E5071A-08A**S E R V I C E****N O T E**Supersedes:
E5071A-08**E5071A ENA Series Network Analyzer, 300 kHz to 8.5 GHz****Serial Numbers: JP1KJ00001 to JP1KJ99999****When E5071A has the step attenuator (33321-60059) and fails Internal Test at Step Attenuator test group, replace the old step attenuator with the improved version (33321-60069) and the revised A86 (E5070-65086).****To Be Performed By: Agilent-Qualified Personnel or Customer****Parts Required:**

Internal Test dialog box (rev.A01.02 or earlier)

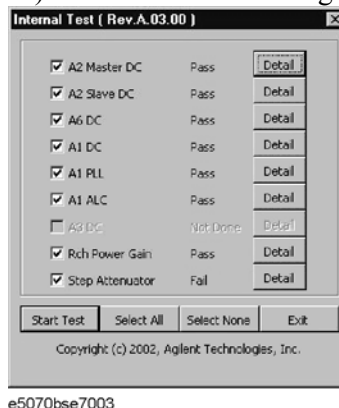
Internal Test is failed on Step Attenuator Test Group, due to the old attenuator reliability.

When the attenuator (33321-60059) is defective, replace with the new replacement attenuator (33321-60069, not 33321-60068) and replace A86 (E5070-66586) with revised one (E5070-65086). There is no need to upgrade firmware for this replacement.
